SEWAGE DISPOSAL SYSTEM

HOWARD COUNTY HEALTH DEPARTMENT
BUREAU OF ENVIRONMENTAL HEALTH
410-313-2640

TO : Amy McMillen
FROM: Bruce Burton
DATE : December 27, 1999
RE : Brantwood 2/1 F99-140 Lot 5

Re: Brantwood lot 5

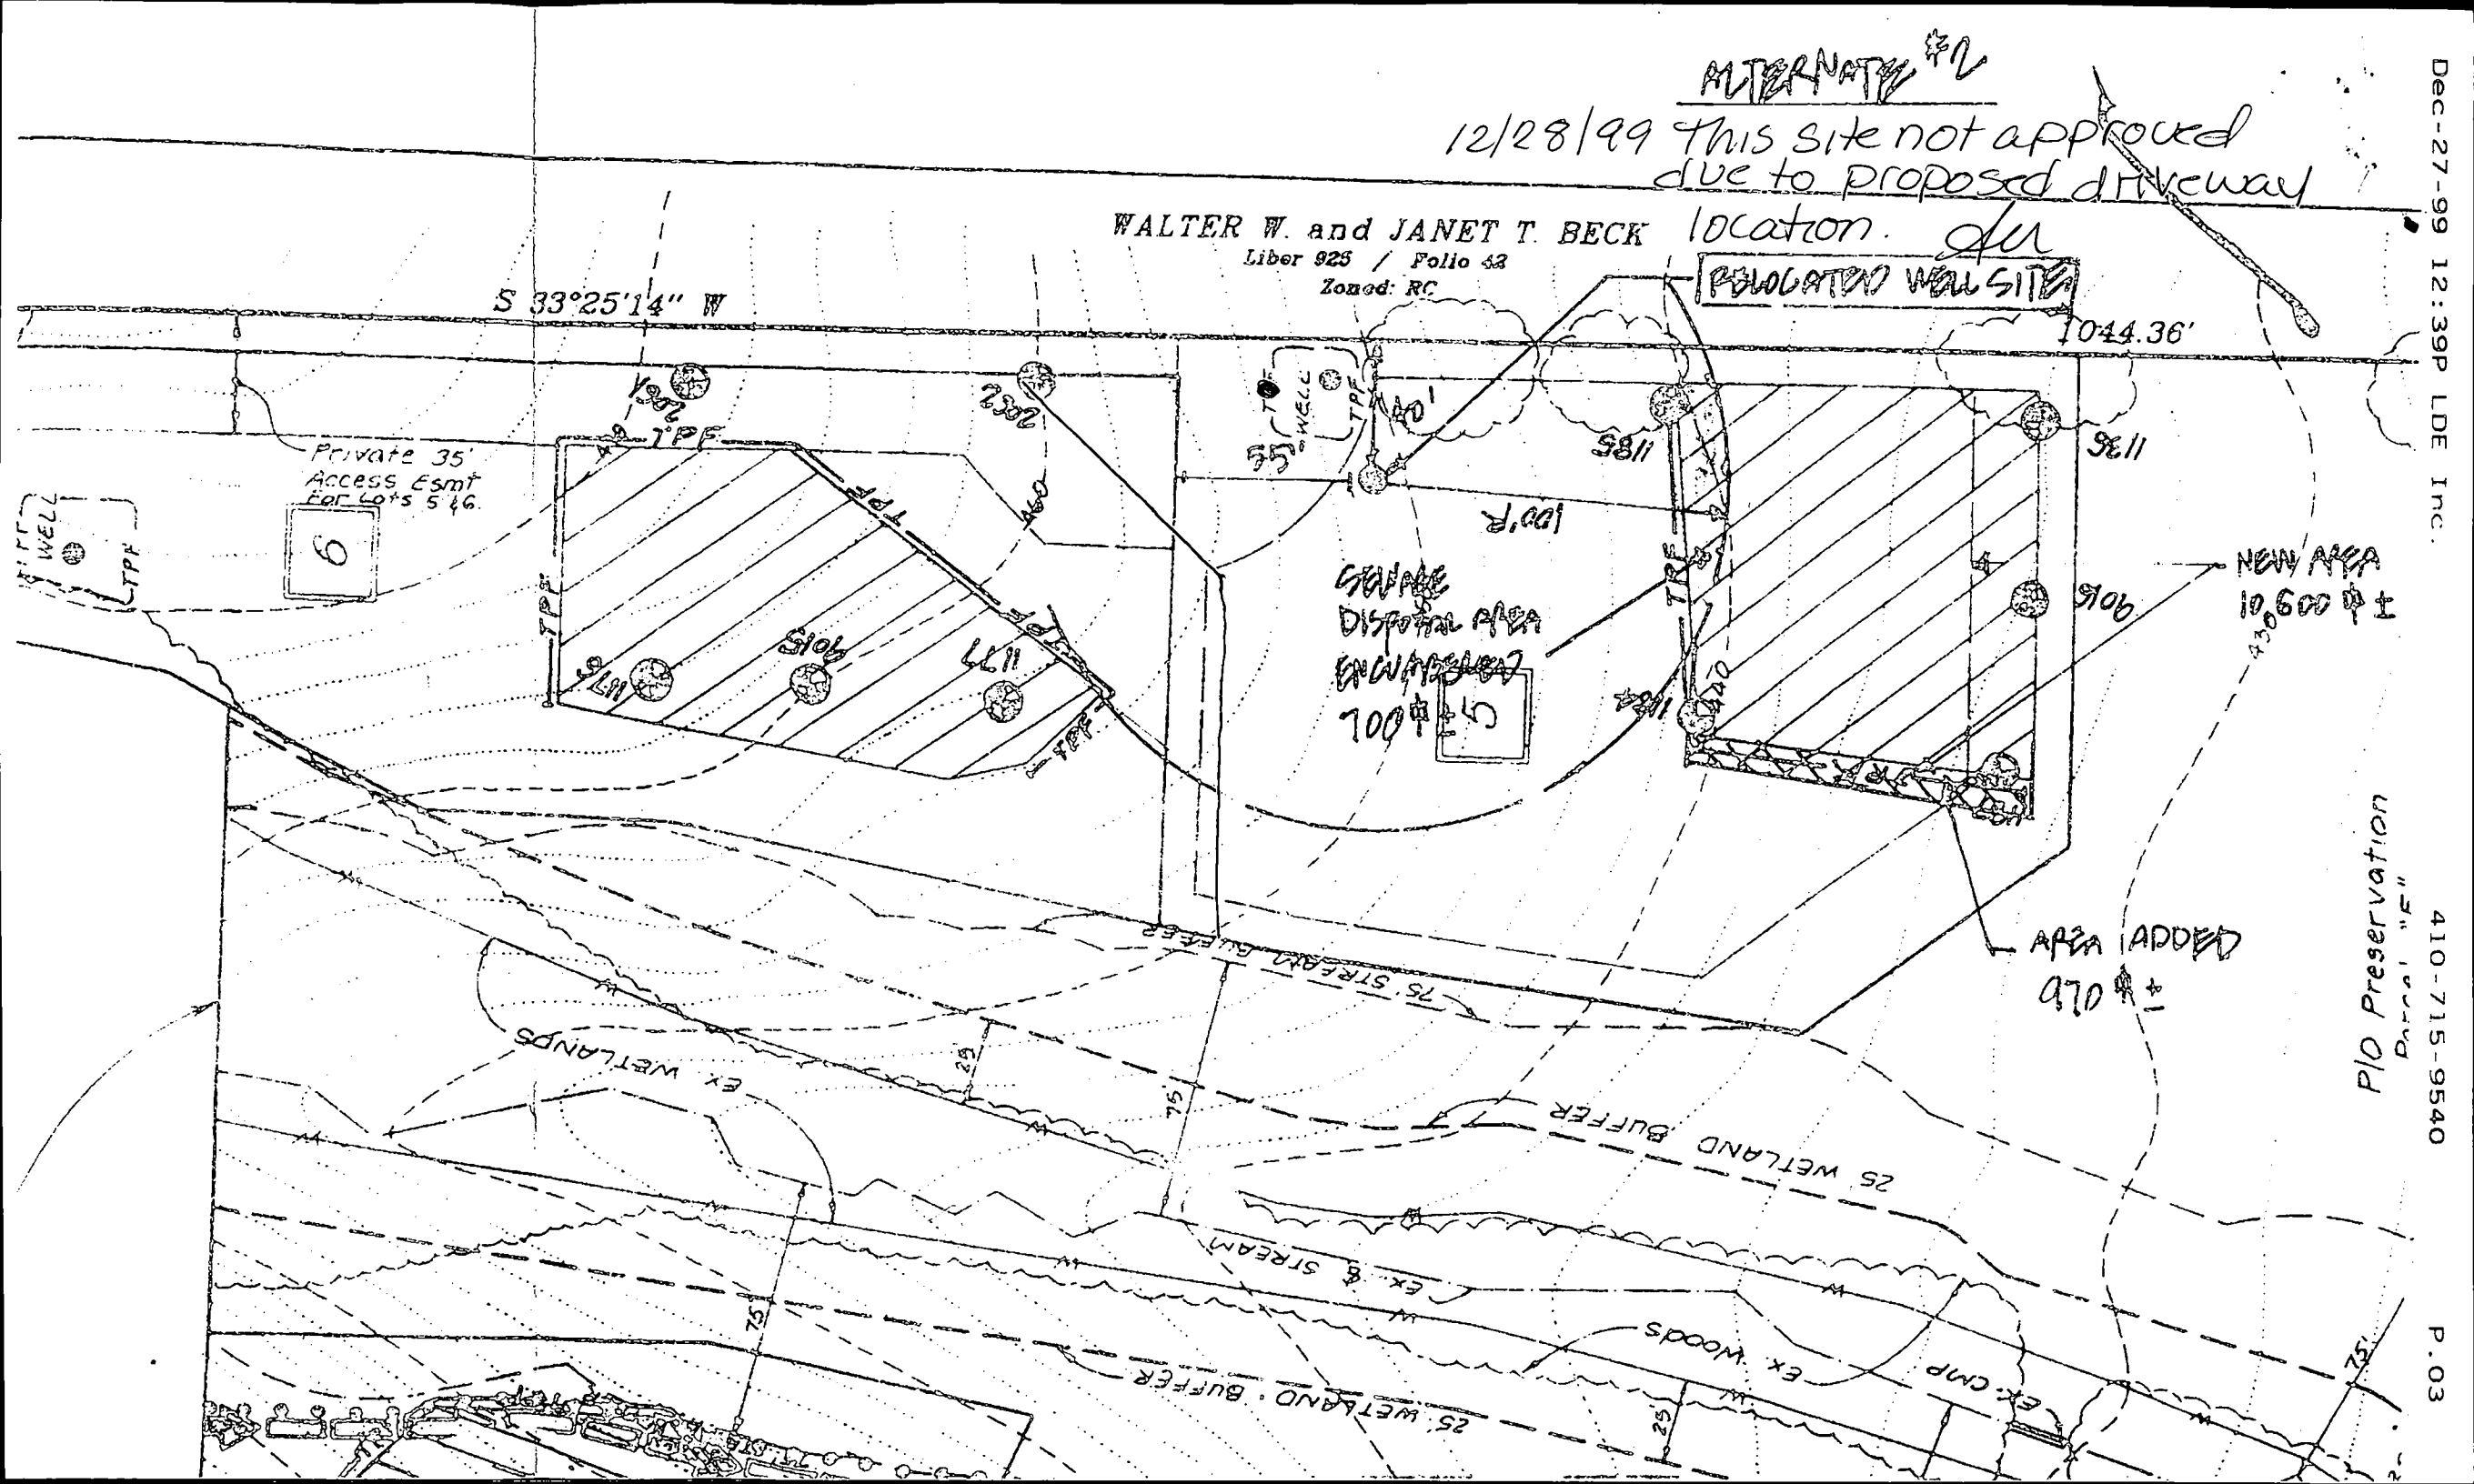
GRAVE DISPOSAL AREA ENLARGED 700 ±

NEW AREA 10,600 ±

AREA ADDED 970 ±

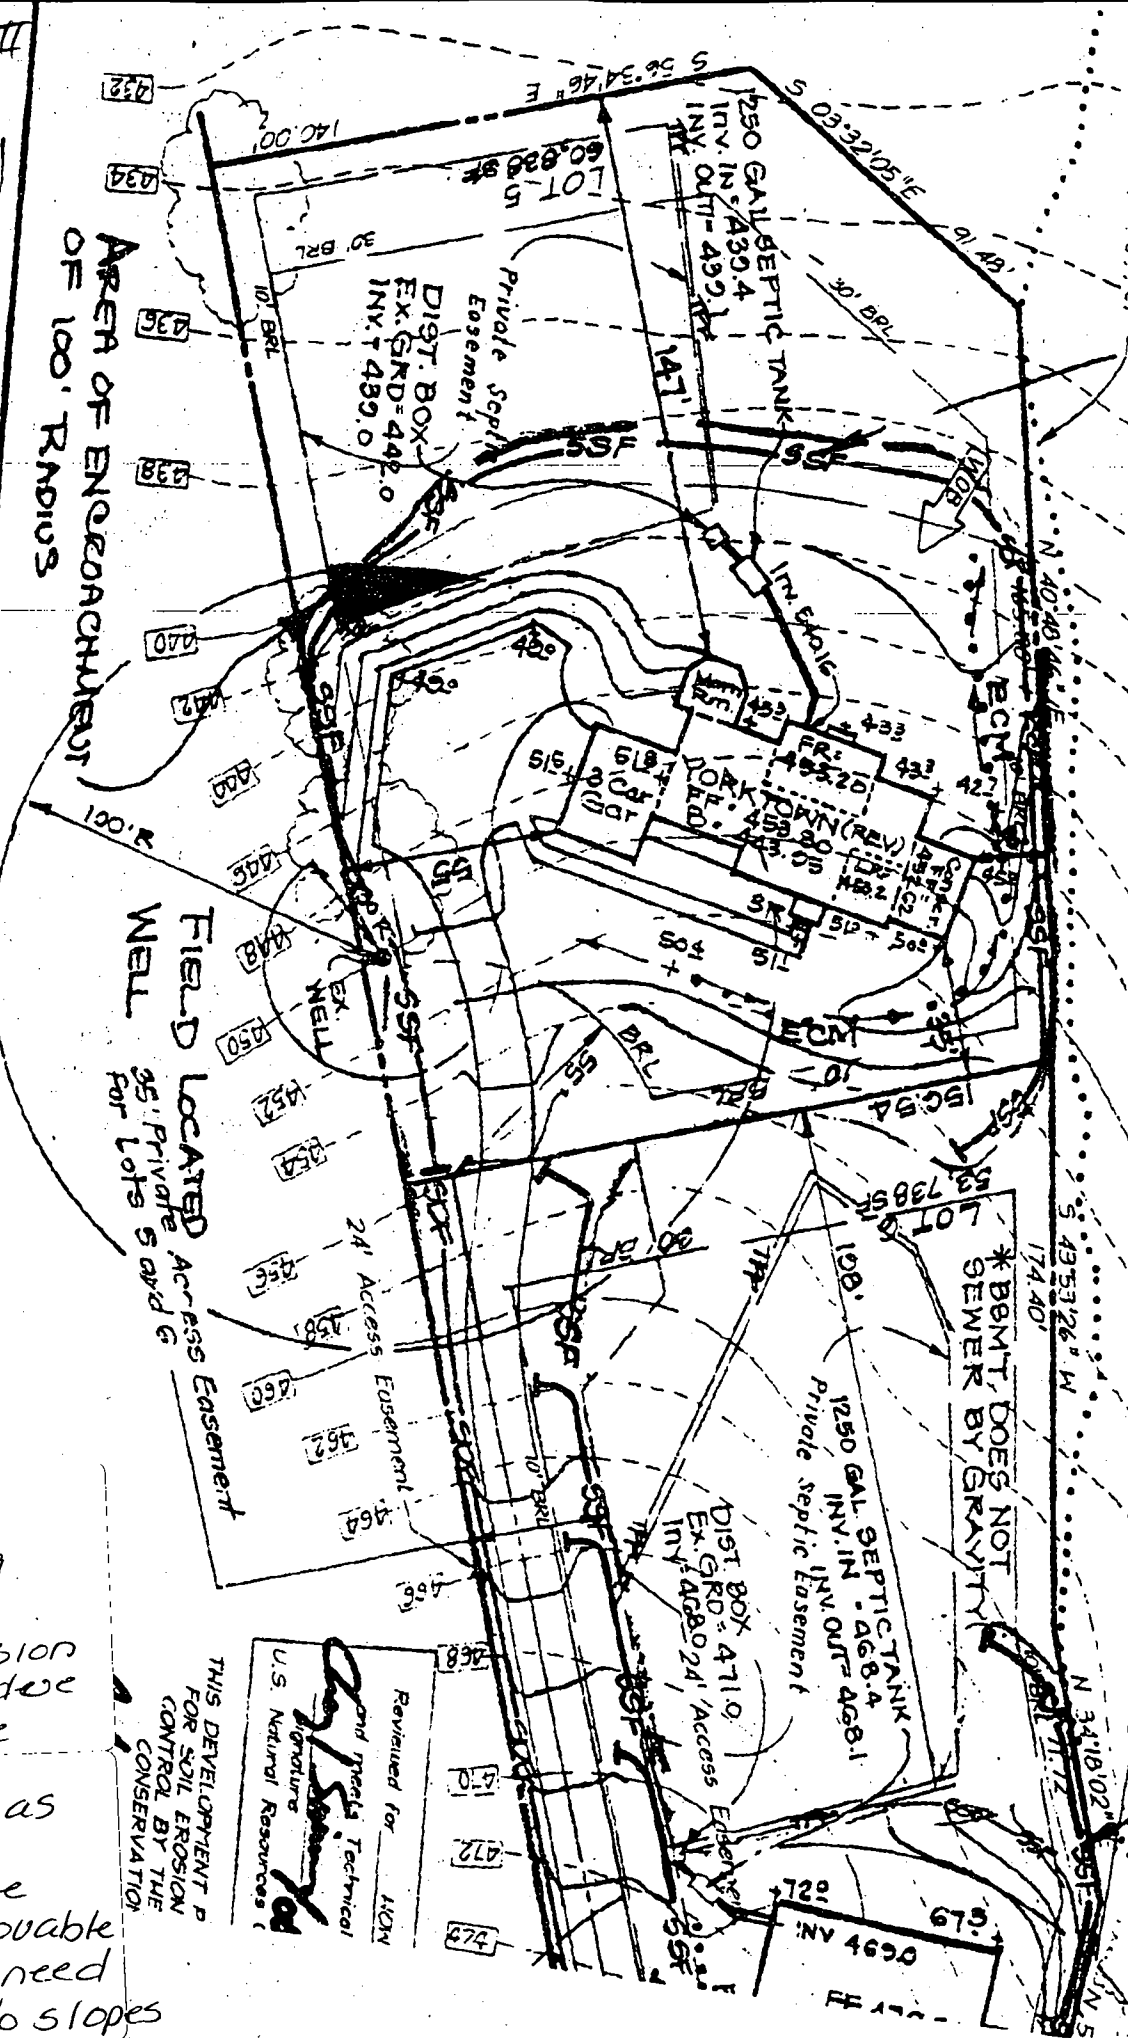
The plan submitted by CF #5 for well sites shows a different well site than shown on your plan. Actually it shows the site you are proposing for alternate #1 - ~~please~~ Also the SDA on the plan you sent on lot 6 has moved - Please advise

Joey Ecker faxed this for approval of an adjustment to esmt. (she apparently wants vs to suggest an adjustment).

But nowhere in file could I find approval of the well site shown. Appears to me the approved site "A11 #3" was elsewhere.

- 11/3/00
- Shown well site was approved on 12/28/99 205' from the rear property line - confusion about approval is due to adjustment of the 156.54 lot line.
- Adjustment to SDA as shown is OK.
- Grading around the driveway not approvable it is >25% & SDA's need to be 25' from 25% slopes

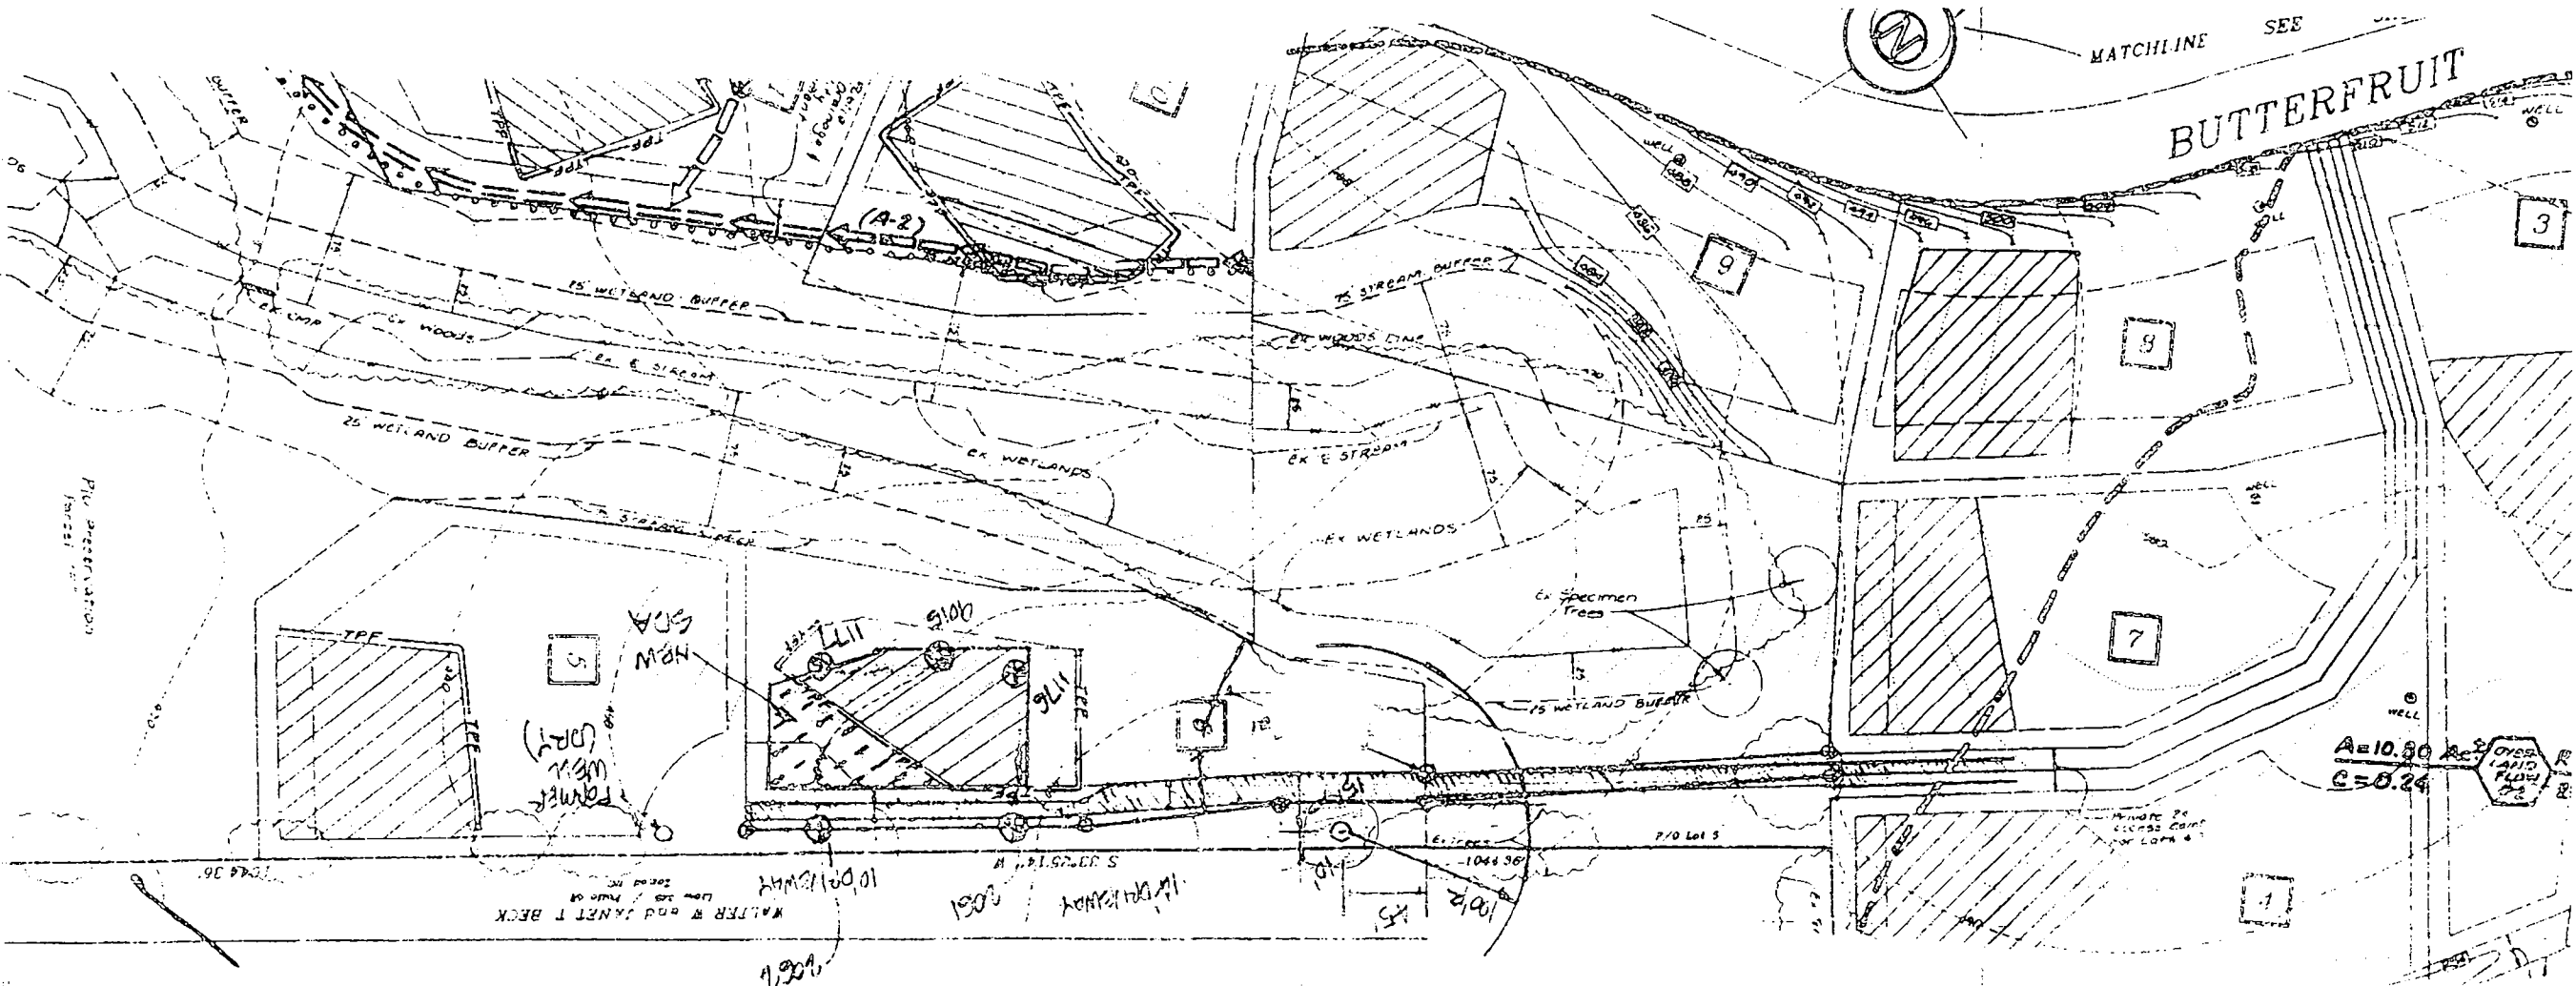
The well driller is presently proceeding with the last alternate site on Lot 5. In the event that this location is dry, we are proposing three (3) additional locations within the Lot 5 fee simple pipe stem.

The present 12 foot wide stem would be enlarged to 23 feet. This width would provide the minimum 10 foot offset from the property boundary and an approximate 11 foot offset from the proposed driveway. This arrangement would be contained within the present 35 foot wide access easement.

1/13/00
 Replacement well site on lot 5 accepted
 as shown - 15' to use-in-common drive
 maintained - SDA on lot 6 adjusted
 up-hill - Will only be drilled if alt. #30 on lot
 5 comes up dry ALL
